GEOLOGICAL SURVEY

Geologic Factors Pertinent To The Proposed A. J. Wiley Hydroelectric Project, No. 2845, Bliss, Idaho

Open-File Report 81-569

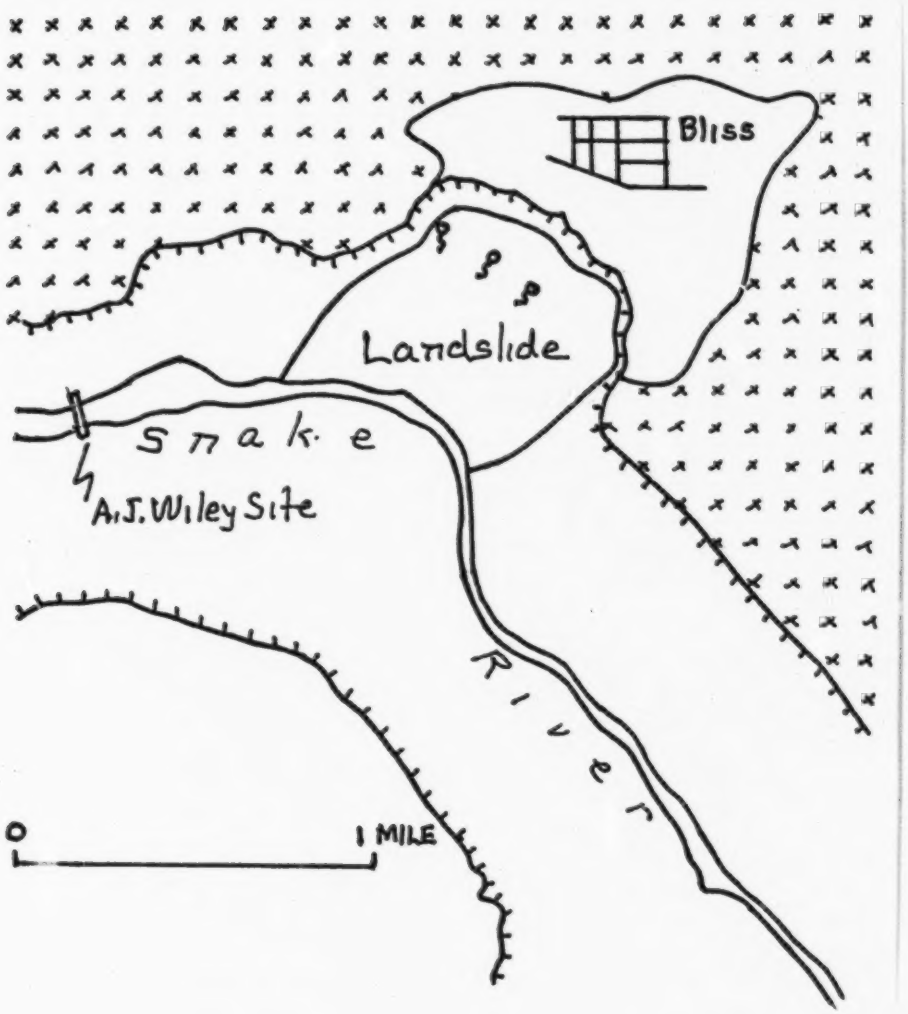
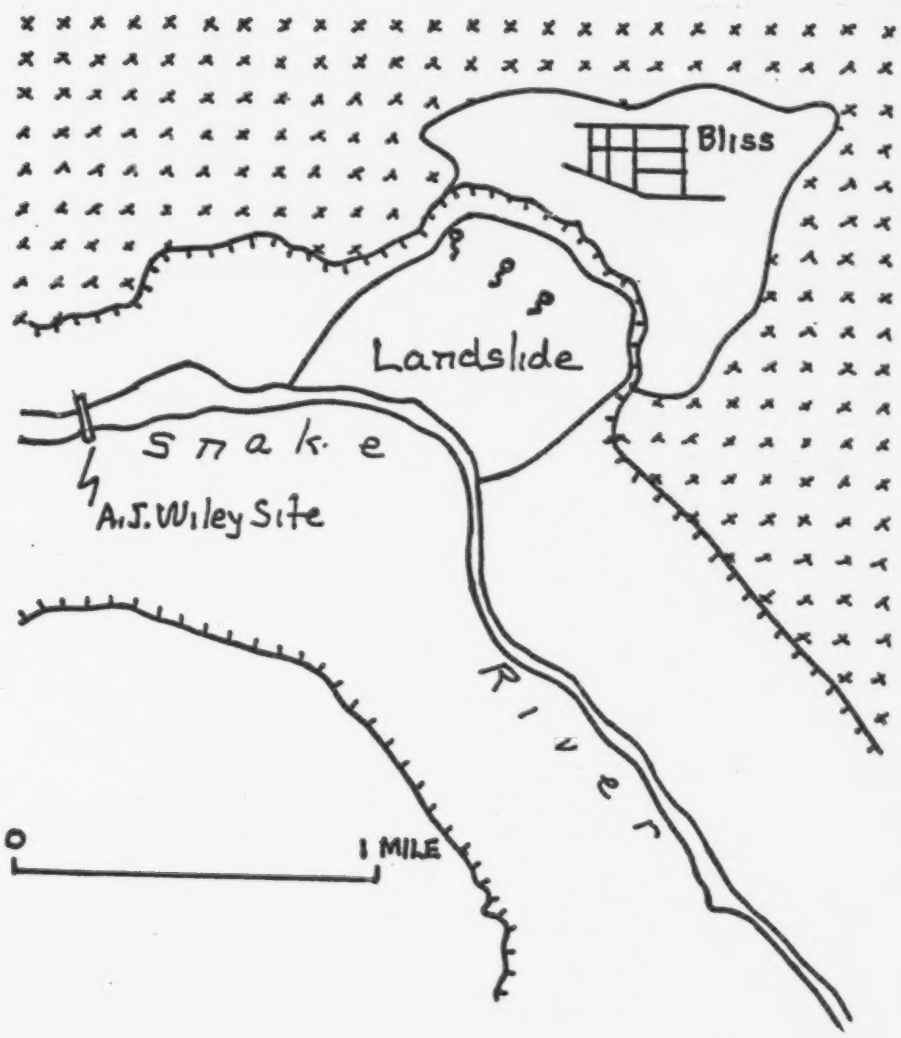
Current movement in the upper part of the Bliss landslide may be induced in part by water that seeps out in the slide area below Bliss at an altitude of 3,000 feet (fig. 14). The seeps are along the trend of the scarp mentioned above. Water usually contributes to the movement of landslides by increasing shear stress (the added weight of the water) and by reducing shear strength (decreased intergranular friction, softening, and the like). It is common knowledge in the area that discharge from the seeps has increased with growing use of septic tanks at Bliss, and

The applicant's present understanding of the Bliss landslide is based only on geologic mapping, although "drilling and testing is planned . . . to assure continued resistance of the hillside to large scale failure" (letter of Carter B. King to Ralph I. Clements, March 17, 1980). The geologic problem presented by the Bliss landslide is not whether it is indeed resisting failure, but whether the landslide will fail during the life of the A. J. Wiley Hydroelectric Project, whether failures can be expected to be caused by the project, and whether failures represent a potential risk to the project itself.

Figure 15.--Representative profile of the Bliss landslide showing two hypothetical positions of concealed Banbury Basalt: A, close to the front of the slide; and B, deeply buried by the upper part. The vertical scale is exaggerated by a factor of two.

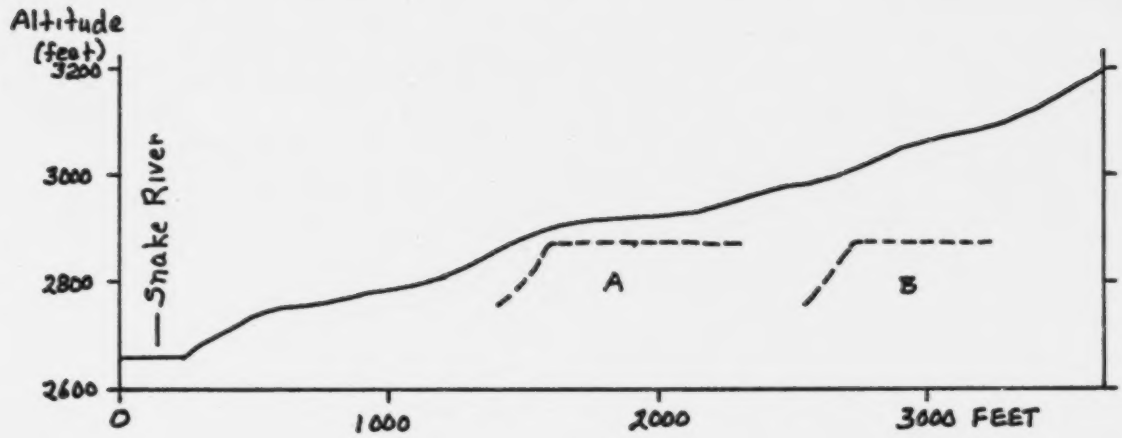
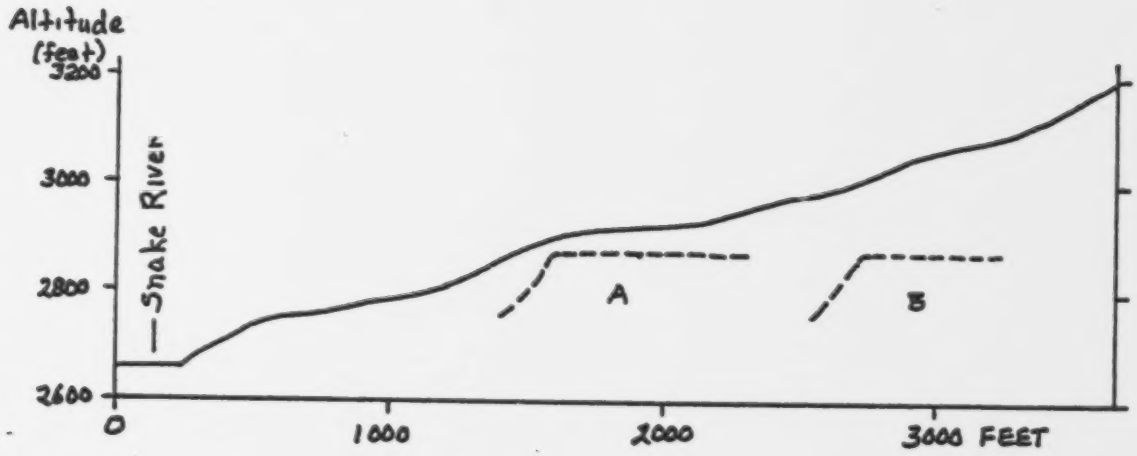
Of particular concern in the upper part of the landslide is the position of the Banbury Basalt, which underlies the Glenns Ferry Formation. If the concealed Banbury is relatively near the front of the slide, at position A in figure 15, it can be expected to increase the stability of the upper part of the landslide--at least in the sense of providing a relatively resistant buttress to movements that may begin at a higher level. On the other hand, if the Banbury is deeply buried by the upper part of the landslide, lying at position B in figure 15, or if it is below the reach of existing slippage surfaces, it would provide little or no resistance. In this circumstance, movements in the upper part of the slide might be propagated to the lower part. An even greater potential danger is that calving at the reservoir might advance upward to the head of the landslide, perhaps leading to enlargement of the slide by headward retreat.

Elsewhere along the canyon of the Snake River, some large landslides in the Glenns Ferry Formation seem to have formed by sudden failure of massive sections of the canyon wall, thus producing widespread sheets of debris in lowland areas. Good examples may be seen in a landslide that covers about 2 1/2 square miles in an area 2-3 miles northwest of King Hill and on the north side of the canyon at the head of Indian Cove. Therefore, large-scale instantaneous collapse of the Bliss landslide is possible, even though large slides of more or less coherent masses are more generally to be expected primarily in indurated rocks (Müller, 1968). Because of the potential hazard, it would be prudent to evaluate the likelihood of widespread failure of the Bliss landslide by making a complete stability analysis. Sudden large-scale collapse of the landslide could displace a substantial part of the proposed reservoir. In this event, the displaced water almost surely would overtop the dam.
